REQUEST

Current Zoning: O-15 (CD) (Office, Conditional)
Proposed Zoning: RAC(CD) (Regional Activity Center, Conditional)

Approximately 1.53 acres located north of Carnegie Boulevard, east of Coca-Cola Plaza, and south of Rexford Road.

SUMMARY OF PETITION

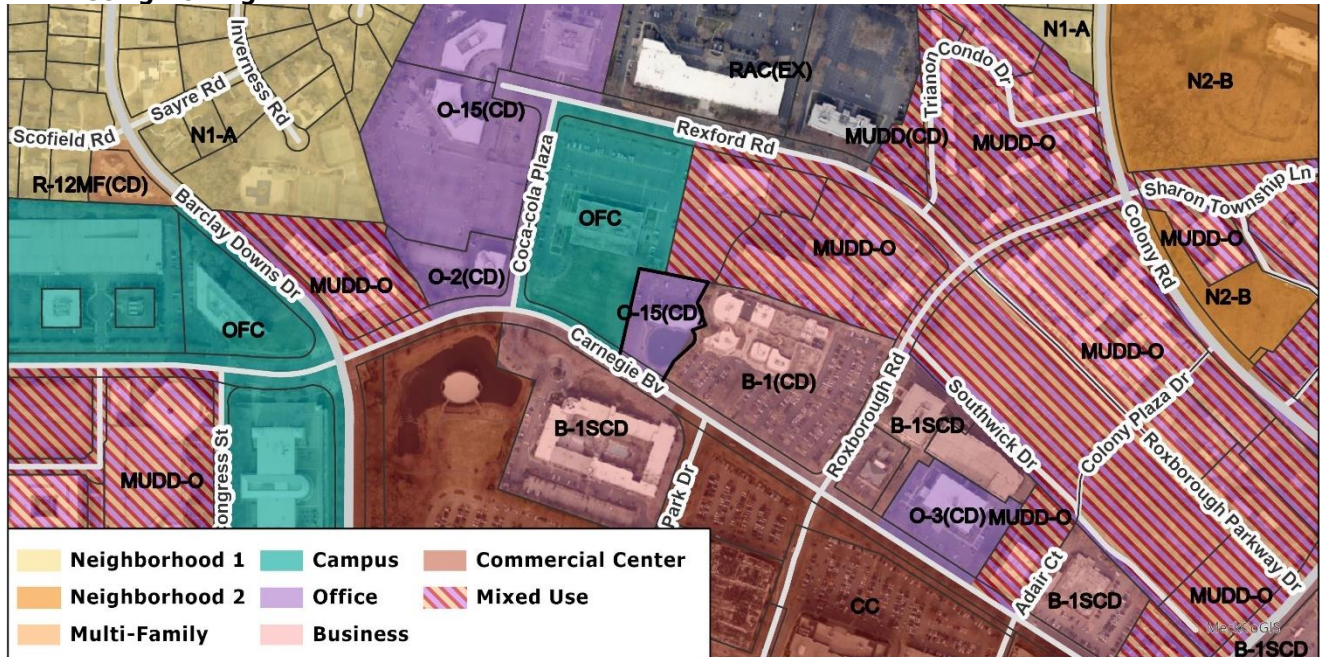
The site plan accompanying this petition contains the following provisions:

- Permits the redevelopment of ±1.53 acres currently zoned O-15(CD) (Office, Conditional) into RAC(CD) (Regional Activity Center, Conditional) to accommodate a mix of office, retail, restaurant, and financial institution uses.

- Allows for up to 68,000 square feet of office uses, 6,000 square feet of financial institution uses, and 6,000 square feet of restaurant/retail uses, together with accessory uses as permitted in the RAC zoning district.

- Requires that a minimum of 80% of the building's ground floor frontage along Carnegie Boulevard be activated with non-residential uses to ensure an active pedestrian environment.

- Provides an 8-foot planting strip and 8-foot sidewalk along Carnegie Boulevard.
- Added potential open space to include but not limited to:
 - Enhanced plantings

- Specialty Paving Materials
 - Shading Element
 - Shade structures shall be added in the space in a manner to provide consistent shade in the space.
 - Seating Options that include moveable tables and chairs, seating walls, swings, or interactive furniture and/or immovable benches. The design shall accommodate 12 people through varied seating components.

- Commits to dedication of right-of-way from the Carnegie Boulevard centerline to the back of future sidewalk, with a 2-foot sidewalk utility easement.

- Identifies potential open space areas that exceed minimum UDO requirements; final design will include at least four enhanced elements such as specialty paving, shade structures, seating, public art, or decorative lighting in accordance with the UDO.

- Vehicular access from Carnegie Boulevard will be provided generally as shown on the site plan, subject to CDOT approval and final engineering.
- **The petitioner shall construct a mid-block pedestrian crossing at Coca Cola Plaza, subject to CDOT approval.**
